JOINT REGIONAL PLANNING PANEL (Sydney West Region)

JRPP No	2015SYW088
DA Number	1410/2015/JP
Local Government Area	THE HILLS SHIRE COUNCIL
Proposed Development	SHOP TOP HOUSING
Street Address	LOT 101 DP 1170464 - WINSTON HILLS SHOPPING CENTRE, 180-192 CAROLINE CHISHOLM DRIVE, WINSTON HILLS
Applicant/Owner	GLENDINNING MINTO & ASSOCIATES
Number of Submissions	In excess of 500.
Regional Development Criteria (Schedule 4A of the Act)	CIV over \$20 million.
List of All Relevant s79C(1)(a) Matters	<ul style="list-style-type: none"> • List all of the relevant environmental planning instruments: s79C(1)(a)(i) <ul style="list-style-type: none"> - State Environmental Planning Policy No. 65 – Design Quality of Residential Flat Development - State Environmental Planning Policy (State and Regional Development) 2011 - The Hills Local Environment Plan 2012 • List any proposed instrument that is or has been the subject of public consultation under the Act and that has been notified to the consent authority: s79C(1)(a)(ii) <ul style="list-style-type: none"> -Nil • List any relevant development control plan: s79C(1)(a)(iii) <ul style="list-style-type: none"> - DCP 2012 Part B Section 6 – Business -

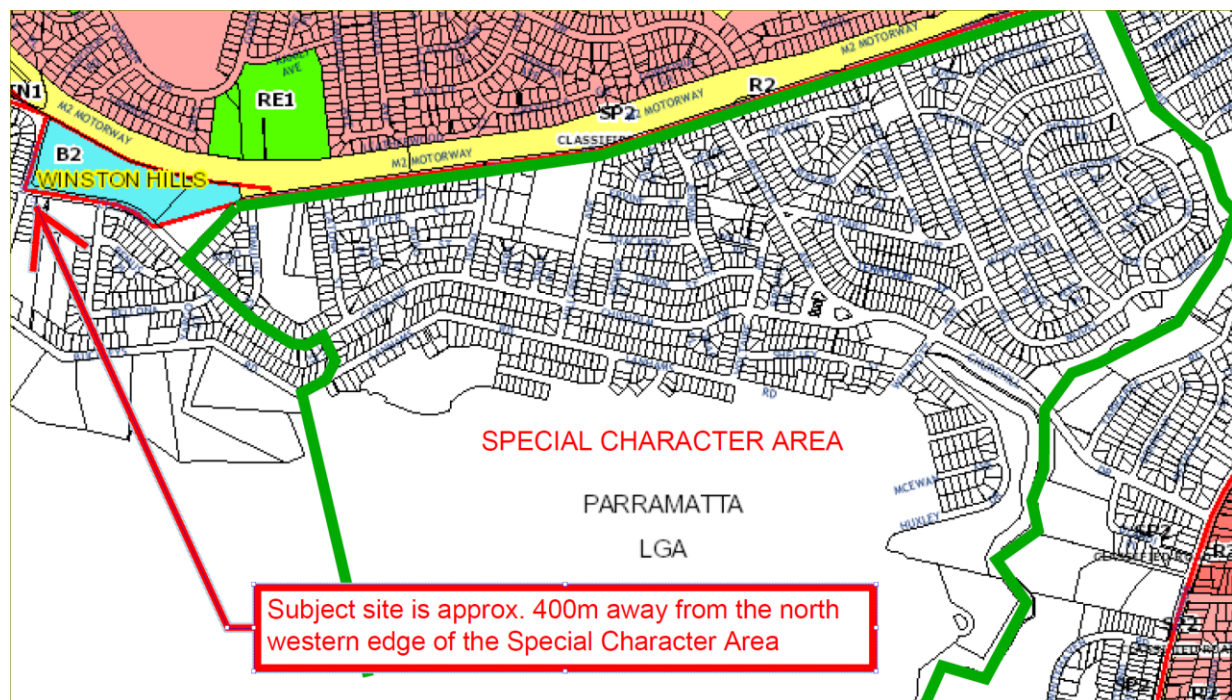
Approximately 400m to the south east of the development site is the north western edge of an area within the suburb of Winston Hills identified as a Special Character Area within the Parramatta Development Control Plan 2011. Refer to map below with the Special Character Area boundary highlighted in green.

In respect to the Special Character Area in Winston Hills which is situated south east of the proposed development, the development controls do not apply, instead the controls provide an insight into the predominant character of the locality.

SHADOW DIAGRAM – MID WINTER – 9AM

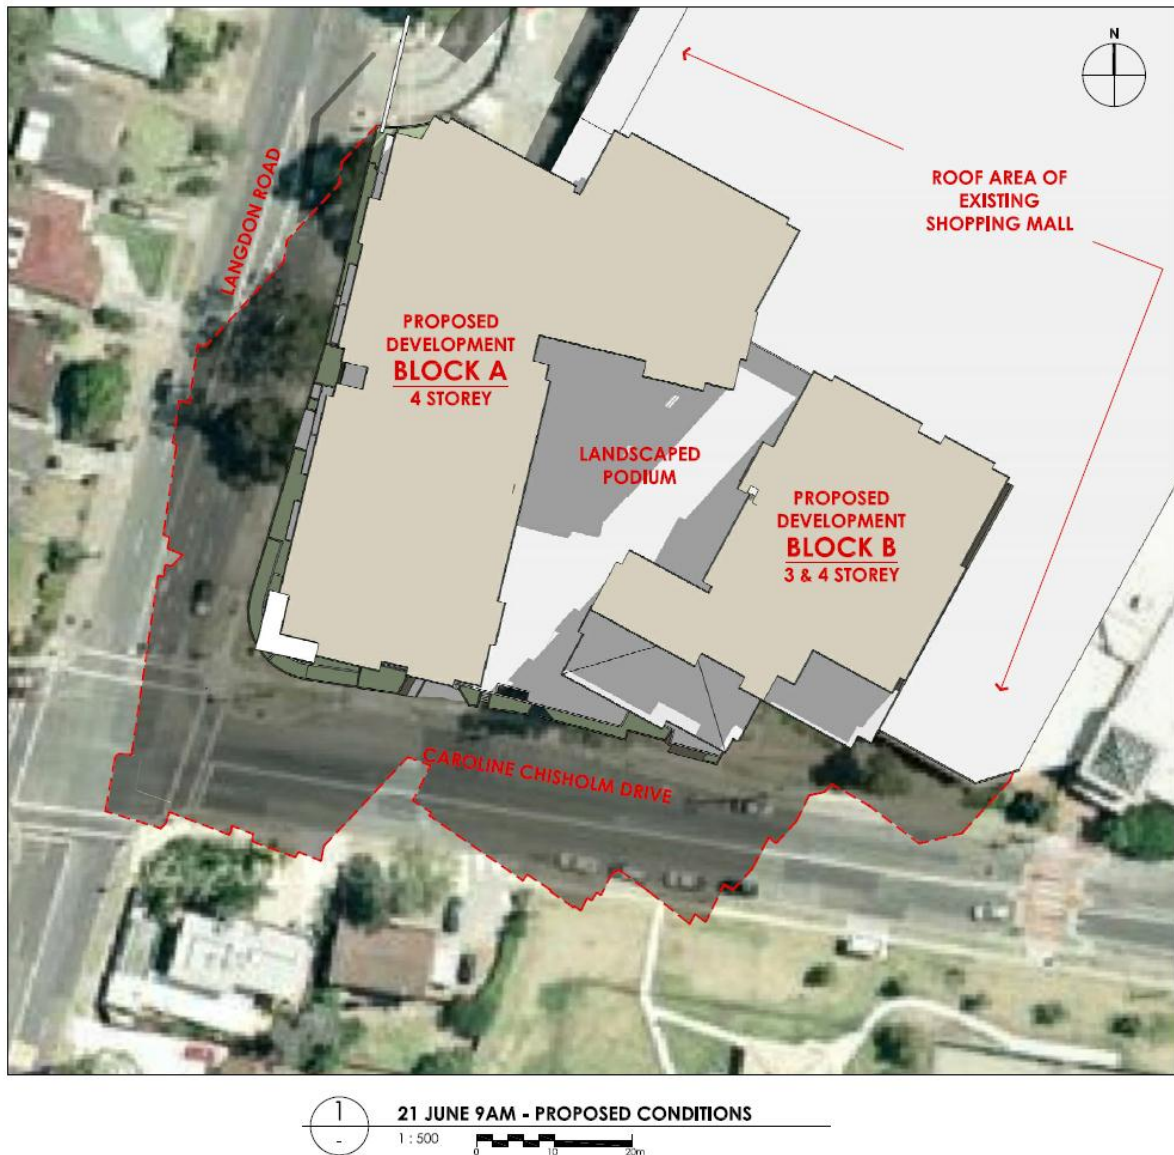
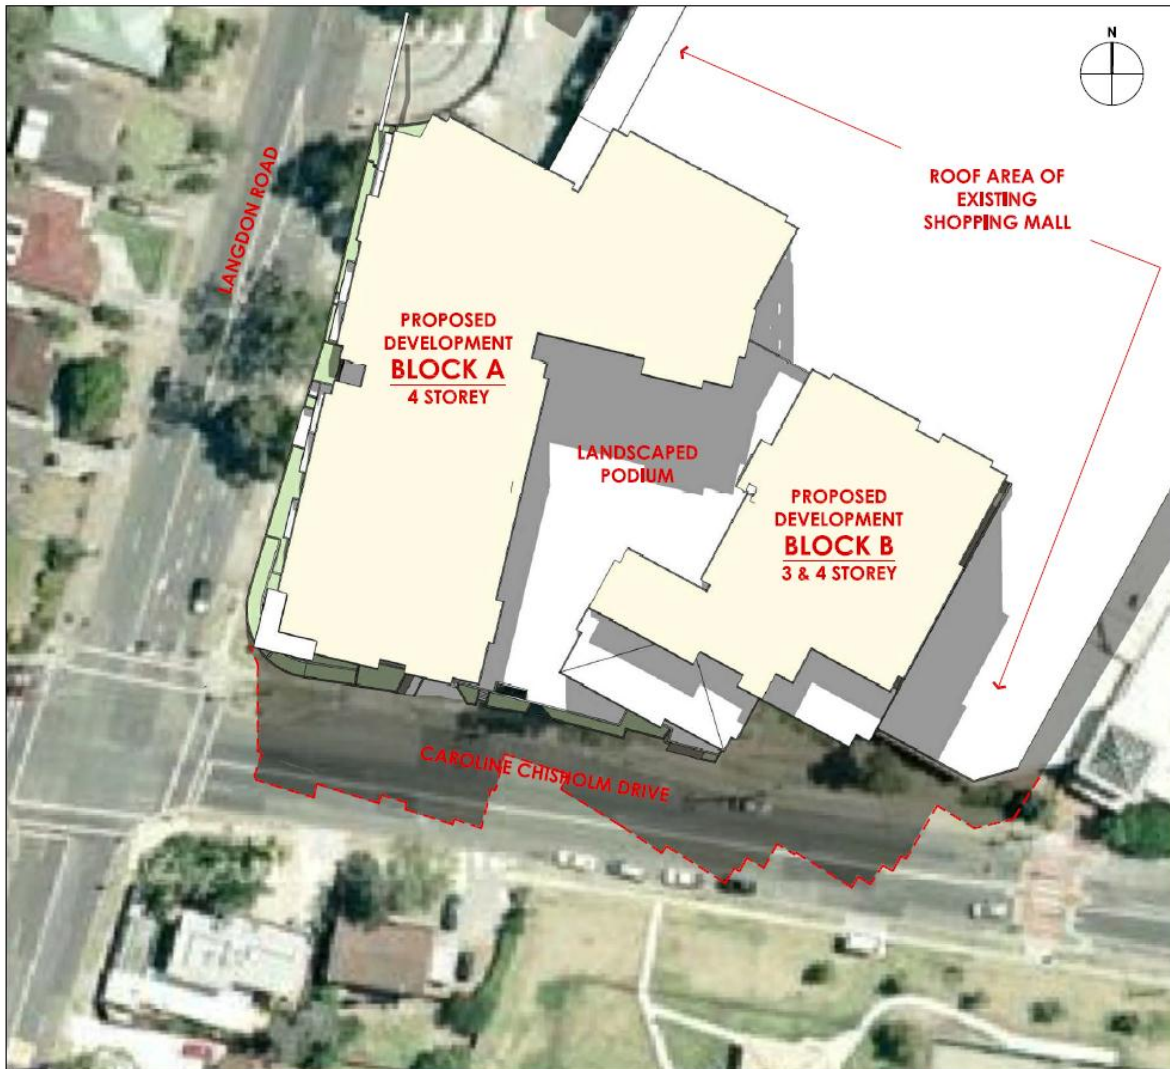
<p>Adjoining residential properties will be overshadowed.</p>	<p>Shadow diagrams during mid-winter show that residential properties on the southern side of Caroline Chisholm Drive will not be overshadowed.</p>	<p>Issue addressed.</p>
<p>Concerns regarding construction hours which have previously occurred past midnight and caused nuisance to the surrounding residents.</p>	<p>If this application is to be approved, Council's standard construction hours will be imposed and any breach to this condition will be dealt with accordingly.</p> <p>However, for the reasons detailed in this report the Development Application is recommended for refusal.</p>	<p>Issue addressed.</p>
<p>The proposal will affect TV receptions.</p>	<p>The impact of the development on surrounding properties in regards to this matter has no sufficient basis to support this claim.</p>	<p>Issue addressed.</p>
<p>Increase in air pollution.</p>	<p>The impact of the development in regard to this matter has no sufficient basis to support this claim.</p>	<p>Issue addressed.</p>
